Intel[®] I/O Controller Hub 6 (ICH6) Family

Specification Update

October 2009

Order Number: 301474-027

Figure 1. LPC Bridge SERR# Generation

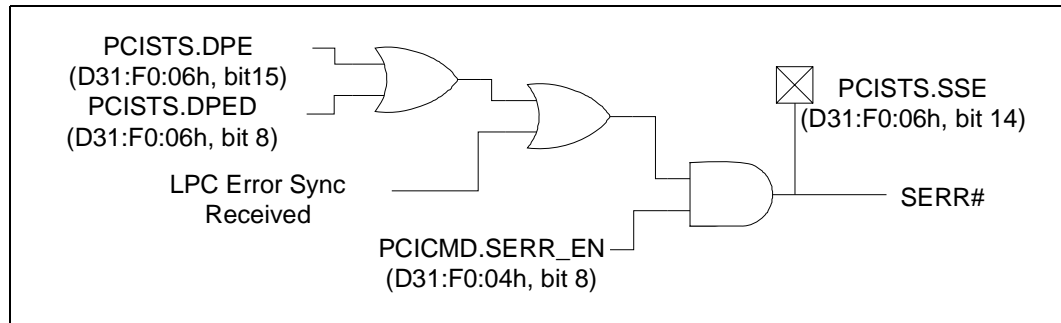
The following is added as section 5.5.2:

The first class of errors is parity errors related to the backbone. The LPC Bridge captures generic data parity errors (errors it finds on the backbone) as well as errors returned on the backbone cycles where the bridge was the master and parity error response is enabled. If either of these two conditions is met, and with SERR# enable (PCICMD.SERR_EN) set, SERR# will be captured.

Additionally, if the LPC Bridge receives an error SYNC on LPC bus, an SERR# will also be generated.
